STAFF REPORT

APPLICATION CSPA 2006-SU-007

APPLICANT:	Discovery Square Ventures LLC
ZONING:	PRM (Planned Residential Mixed Use) WS (Water Supply Protection Overlay)
PARCEL:	24-4 ((1)) 6H
SITE AREA:	6.01 acres
PLAN MAP:	Mixed Use
PROPOSAL:	To amend the Comprehensive Sign Plan for the multi-family residential building.

Comprehensive Sign Plan Amendment

Label	Sign Area Allowed by Art. 12	Proposed Sign Area	Sign Copy	Location
Building Identification Signs				
X5.01	12 SF (total) Sect. 12-202 (2)	137.53 SF

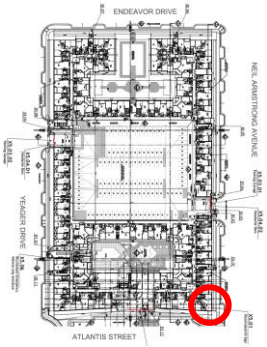
The proposed building identification sign, X5.01, is located near the southeast corner of the building and would be visible from Centreville Road. The building mounted sign consists of lettering that is 17 inches high by 35 feet long (placed in a vertical orientation) and the logo, which is 7 feet-4 inches by 4 feet.

X5.02-a	12 SF (total) Sect. 12-202 (2)	165.11 SF

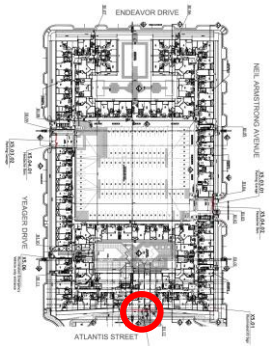
The proposed building identification sign, X5.02-a, is a canopy-mounted sign near the main building entrance on Atlantis Street. The lettering is 16 inches high by approximately 34 feet long, and the logo is 6 feet by 11 feet.

Figure 2 – Sign X5.02-a; Source: CSPA

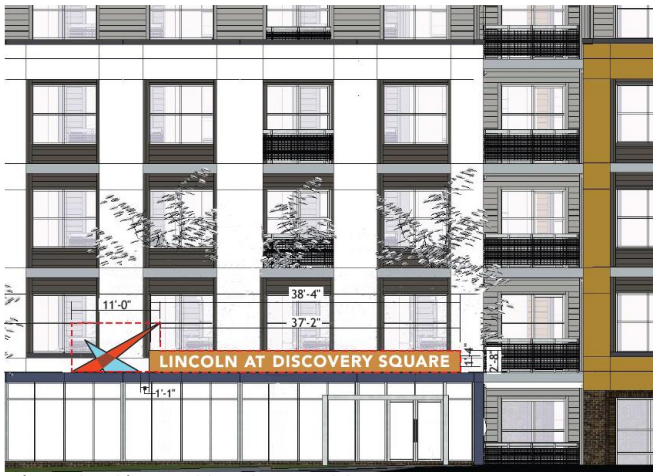
The proposed CSPA provides two primary building identification signs and ancillary signage. The parking and other ancillary signs are not significantly larger than that which could be obtained by right pursuant to Article 12 of the Zoning Ordinance. Building identification sign X5.02-a is proposed to be mounted on the canopy above the first floor level, near the main entrance on Atlantis Street. This sign would face the approved retail and office uses to the south. Staff believes that the size of the

sign is suitable, given its location and that this is the only sign identifying the main building entrance.

Figure 3 – Sign X5.01; Source: Exhibit prepared by applicant

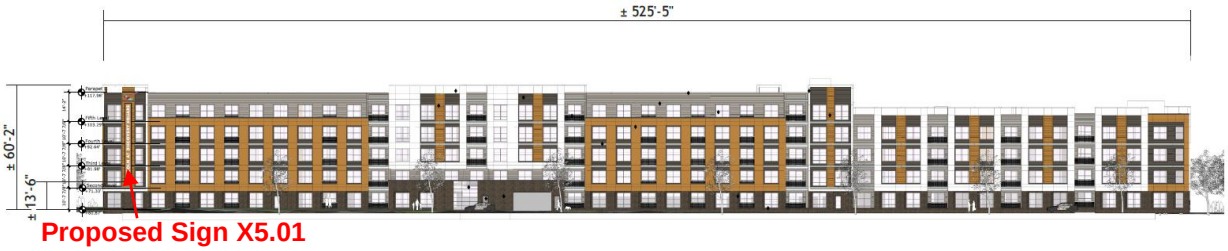
Staff also believes that building identification sign X5.01 is appropriately sized, considering the scale of the building, and to permit visibility from Centreville Road, a 4-lane, divided minor arterial (Type A).

As indicated in the illustration above provided by the applicant, the building is approximately 525 feet long and 60 feet high. The sign, therefore, represents approximately 0.46 percent of the façade. The sign would be viewed from a distance of approximately 285 feet from a vehicle in the nearest north-bound lane at the stop light on Centreville Road and Atlantis Street/Kinross Circle.
